BEACON PLANNING BOARD
One Municipal Plaza - Courtroom
BEACON, NEW YORK 12508
Phone (845) 838-5002 Fax (845) 838-5026

The Planning Board will meet on **Tuesday, May 8, 2018** in the Municipal Center Courtroom. A work session will take place at 7:00 PM for a training workshop, discussion of agenda items and/or topics of interest to the Planning Board. The regular meeting will begin immediately thereafter, but not later than 7:30 p.m.

City of Beacon Planning Board
5/8/2018

Special Use Permit Application
Sheet 1 of 5 - Site Plan

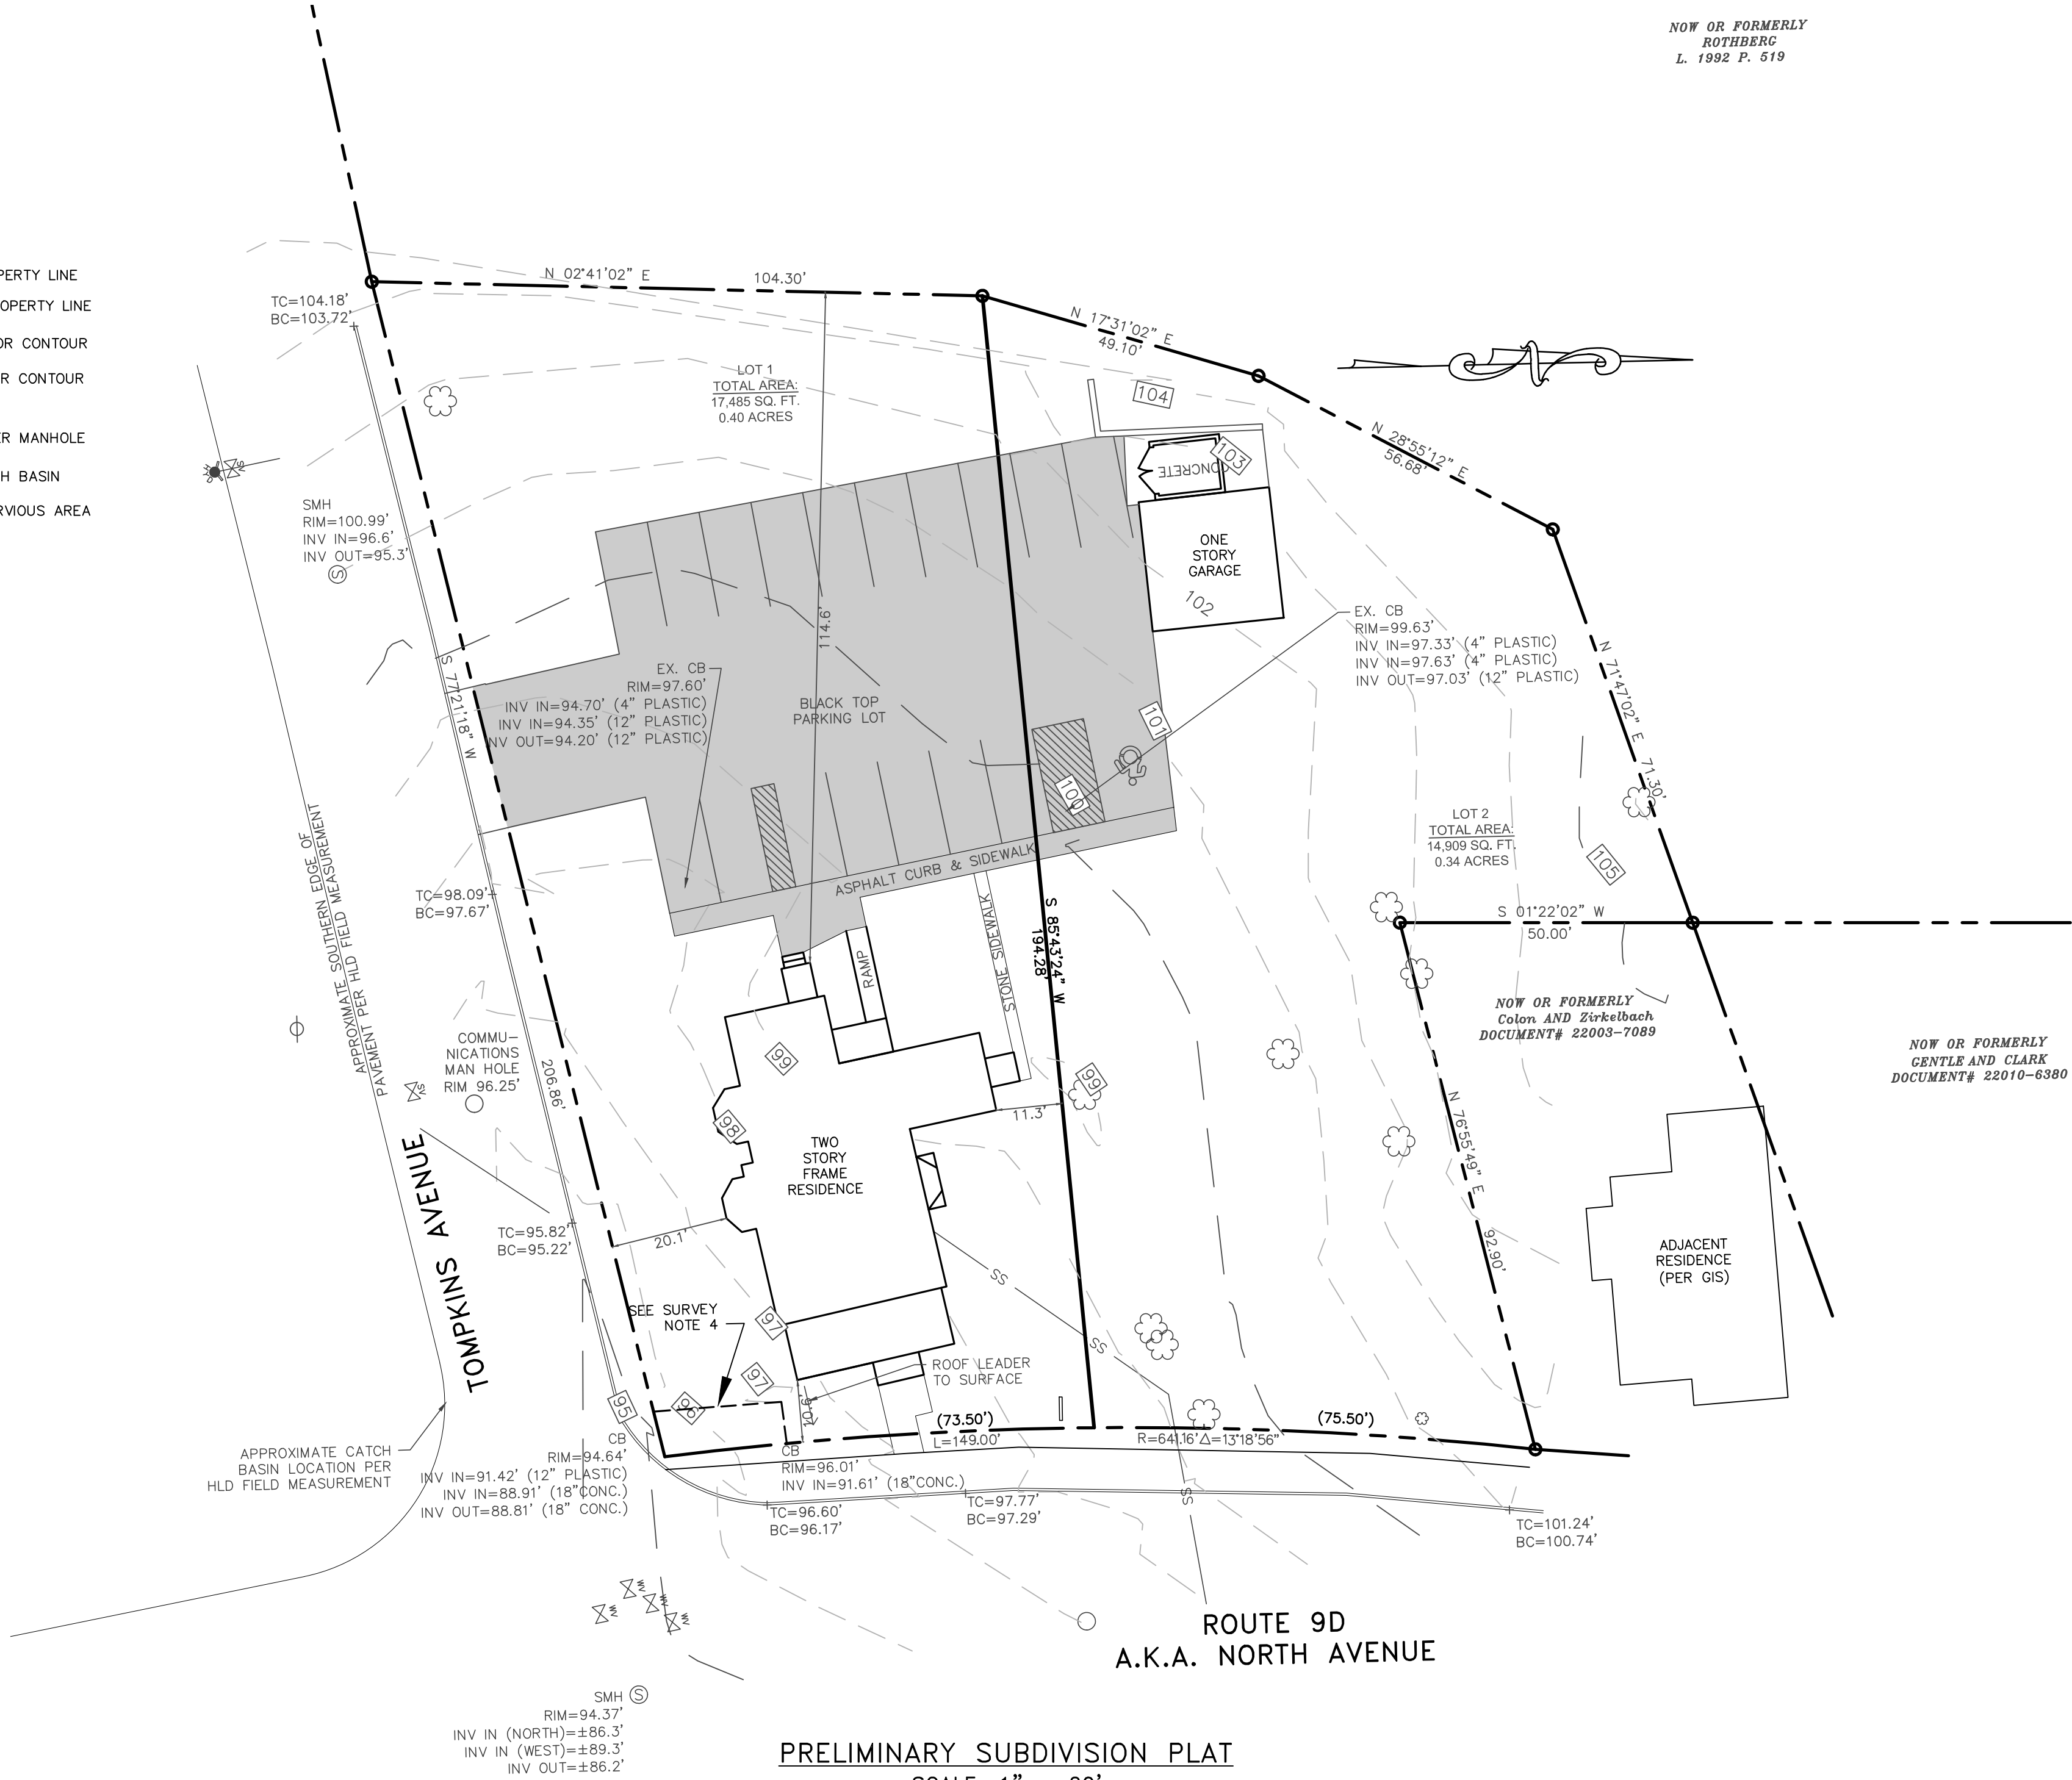
2. The Schedule of Regulations on the previously submitted Subdivision Plat does not entirely match the Zoning Regulations Table on Sheet 1.
3. The Sheet 1 boundaries and setbacks for Lot 1 are inconsistent with the boundaries and setbacks on Sheet 2. Also, the original parcel sizes indicated on Sheets 1 and 2 do not exactly match.

1. Sight distance information has been included on the plan in this submission.

Sheet 1 of 5 - Site Plan

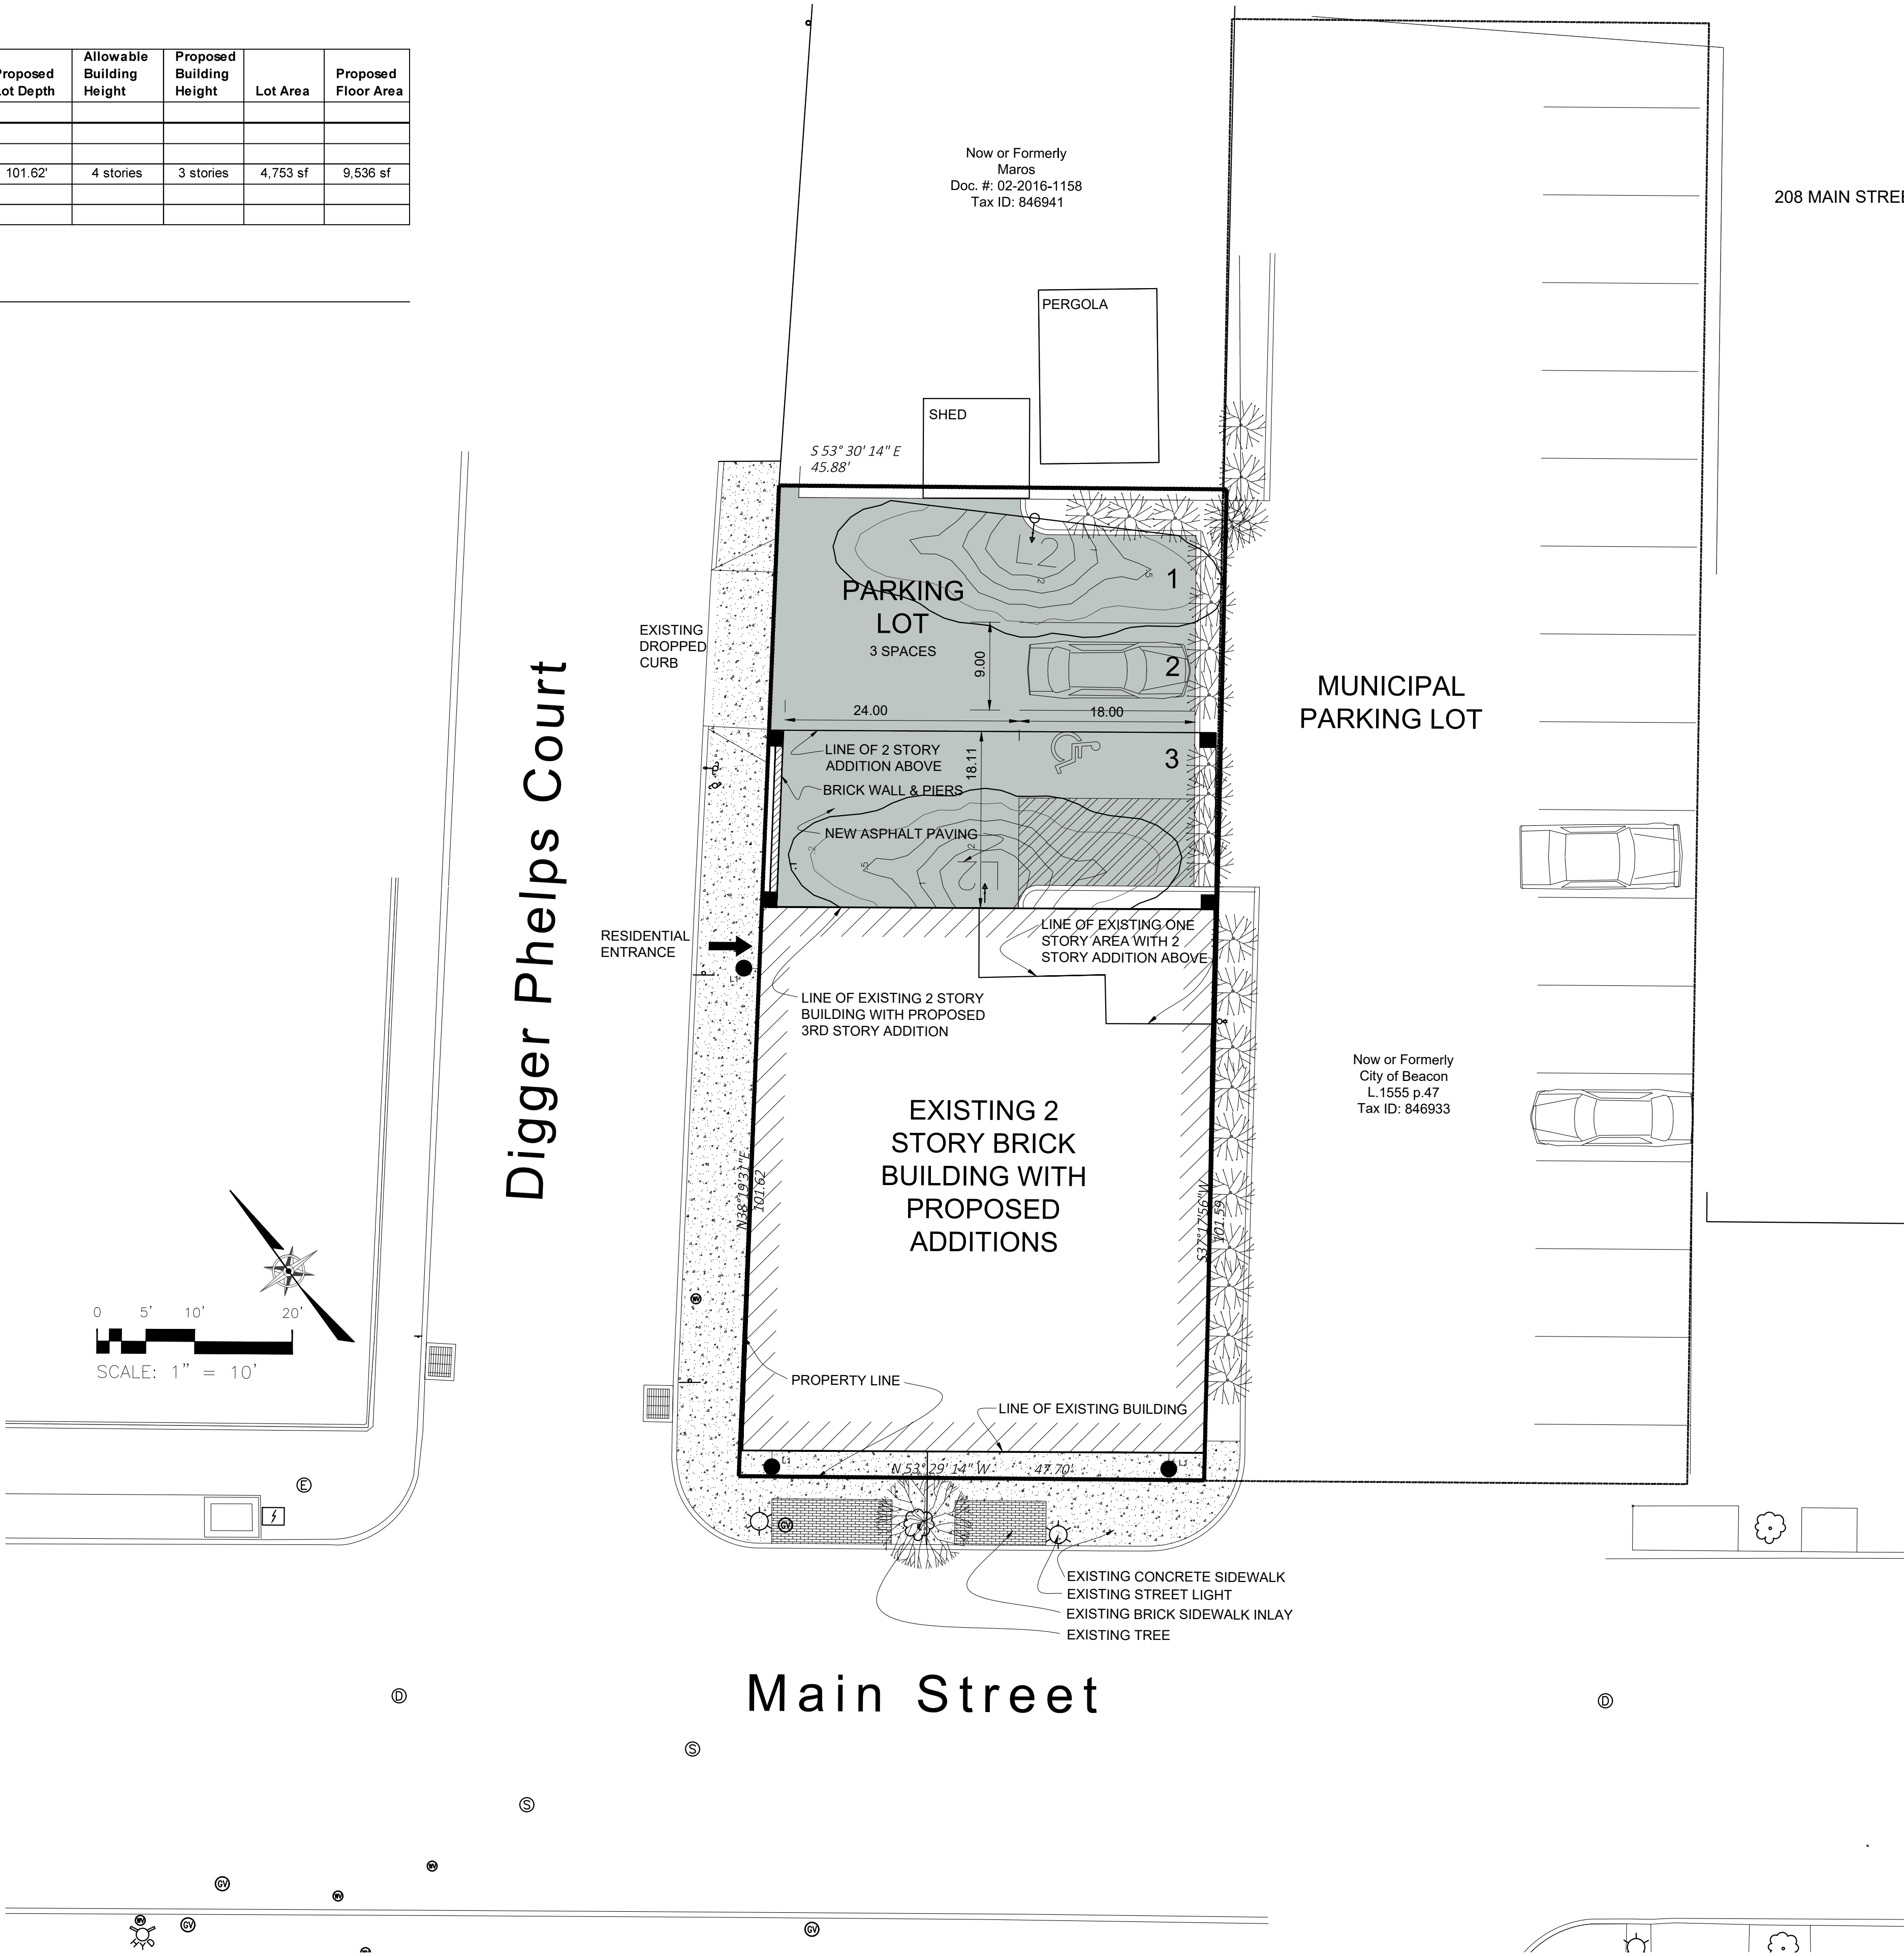
2. In the Sheet 1 Bulk Table the front setback in the CMS district is 0 to 10 feet, so the existing setback is conforming. The frontage required is 80 percent. The minimum landscaped area is 10 percent, which should be represented in the table.

3. In the Sheet 1 Zoning Summary the parcel is not in the Historic Overlay District.
4. The Building Inspector should confirm the 1964 parking exemption analysis. If additional parking is not required, the EAF Section B reference to a ZBA parking variance should be removed.

Site Plan & Special Use Permit Application
Sheet 2 of 5 - Survey & Existing Conditions

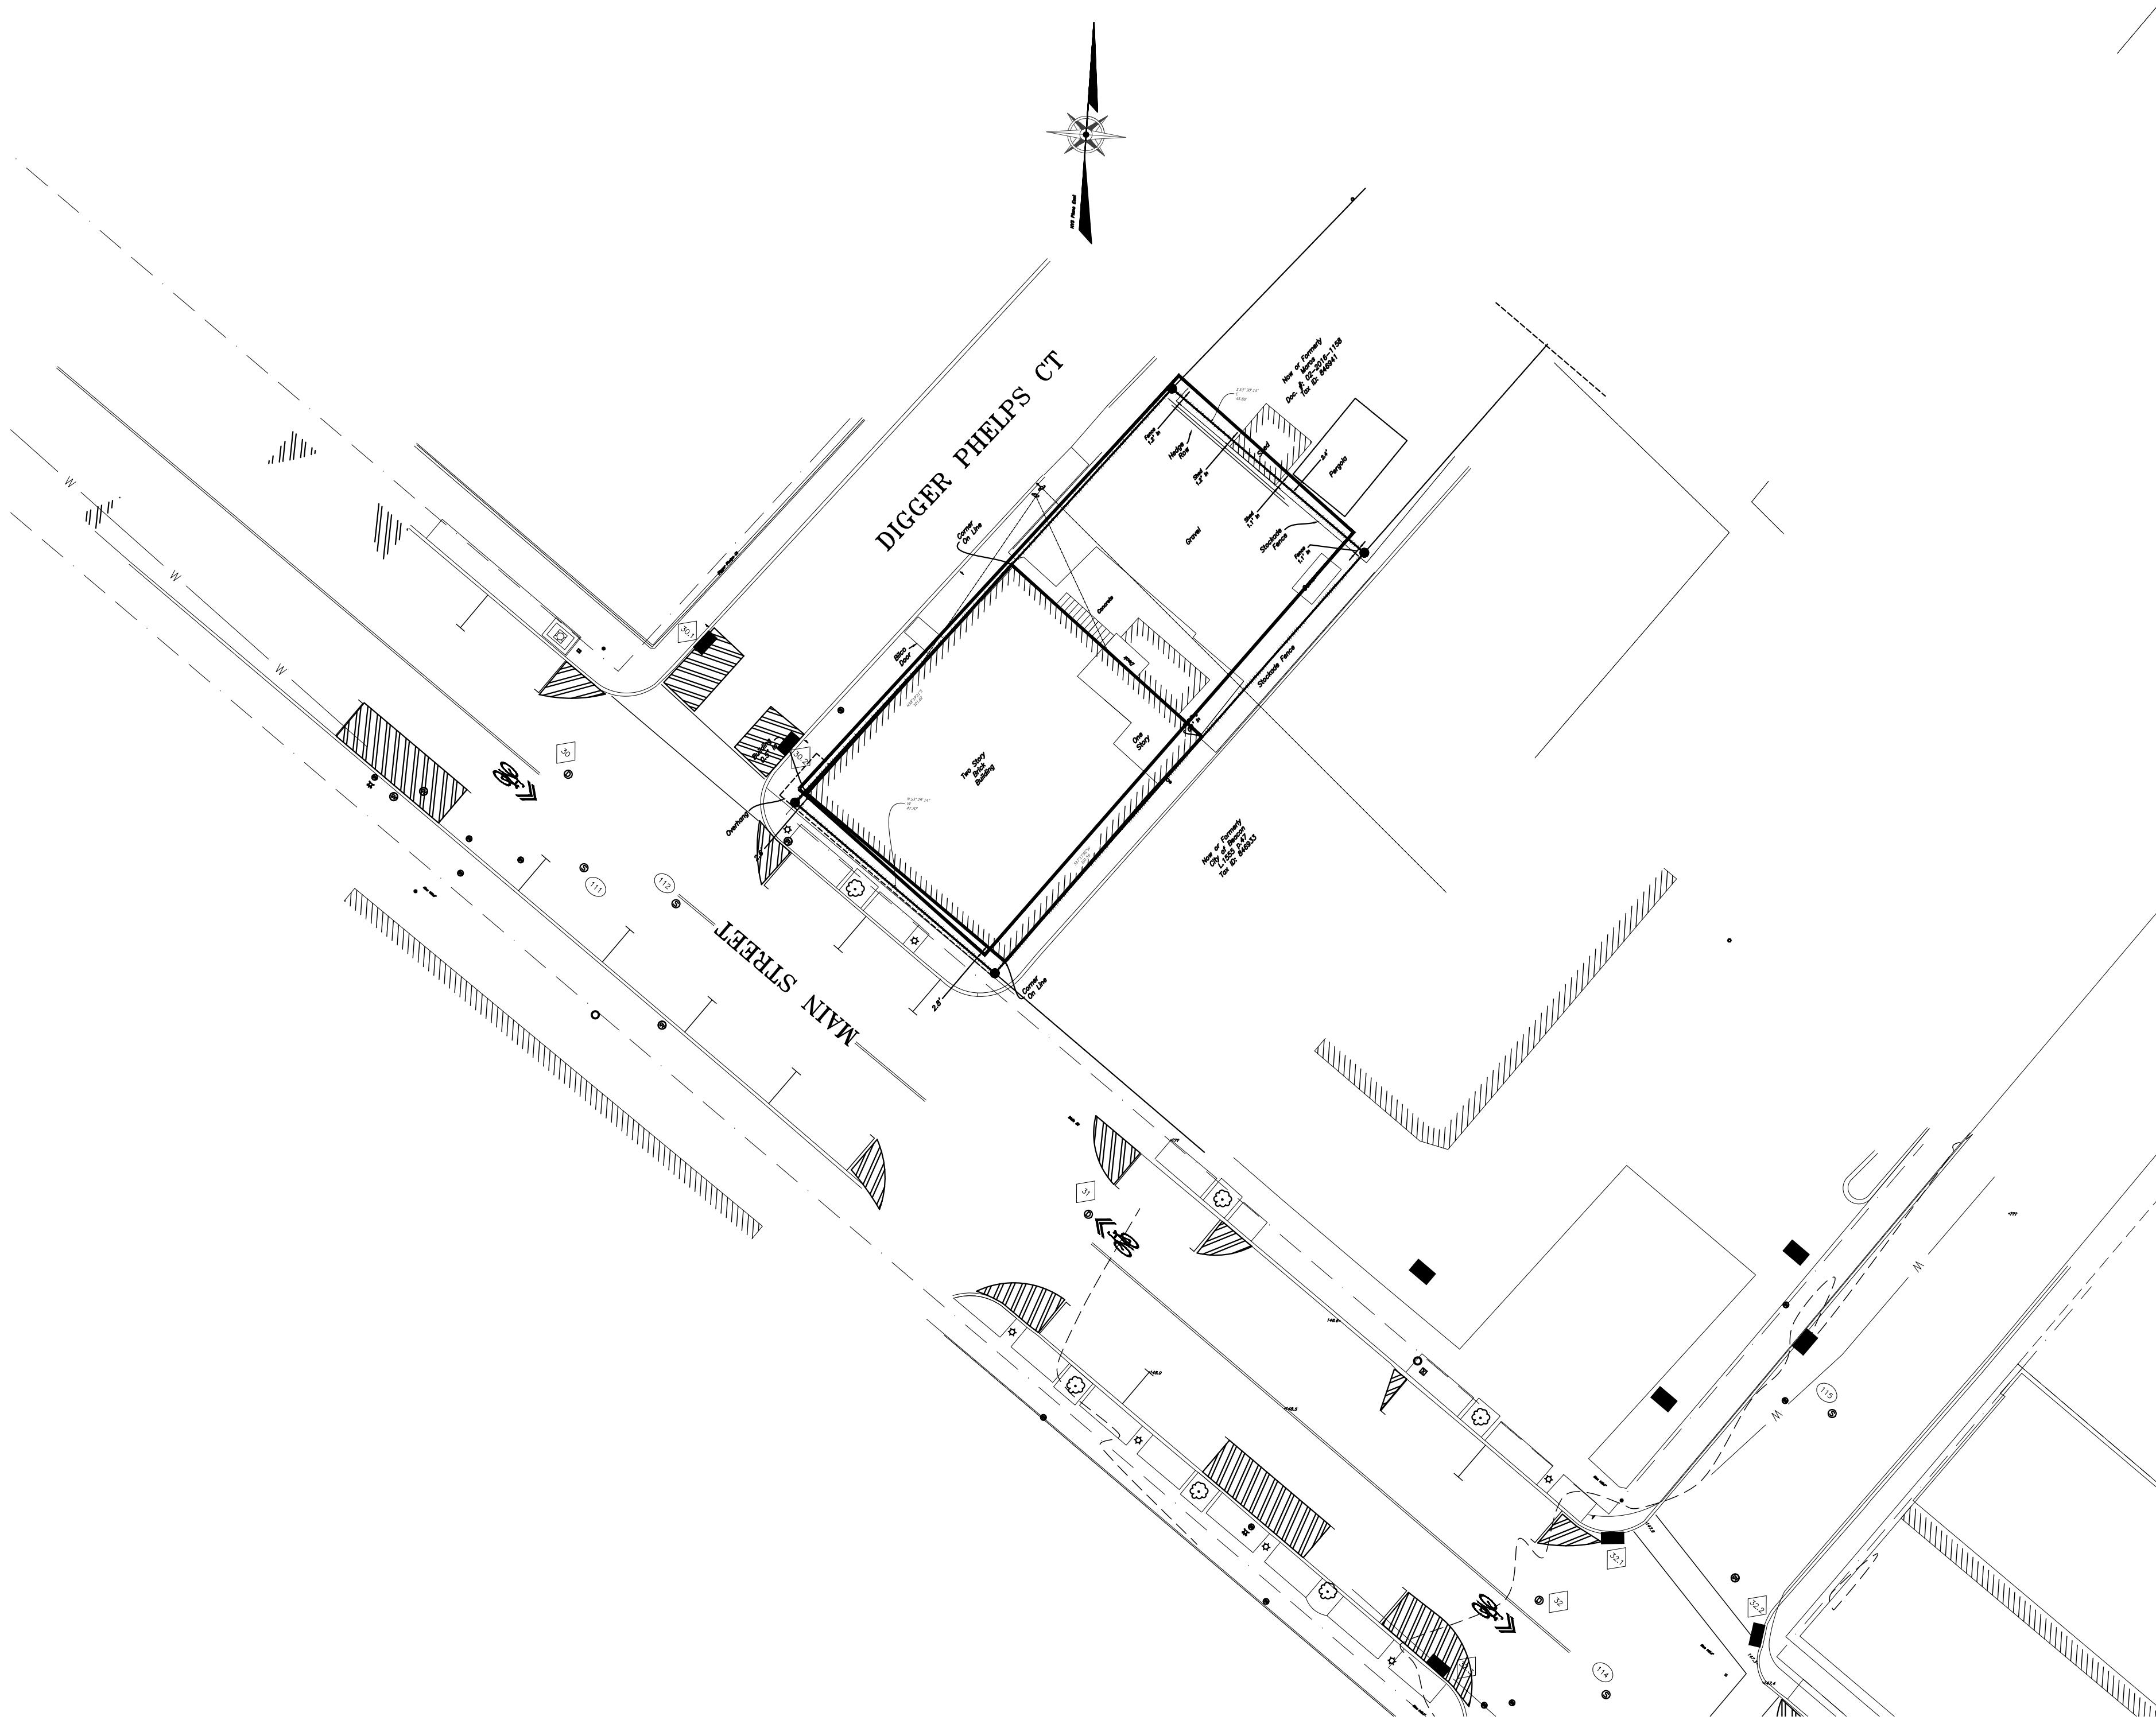
1. The applicant will need to resolve the shed and fence encroachment along the north property boundary. The Sheet 2 survey has difficult to understand overlapping lines.
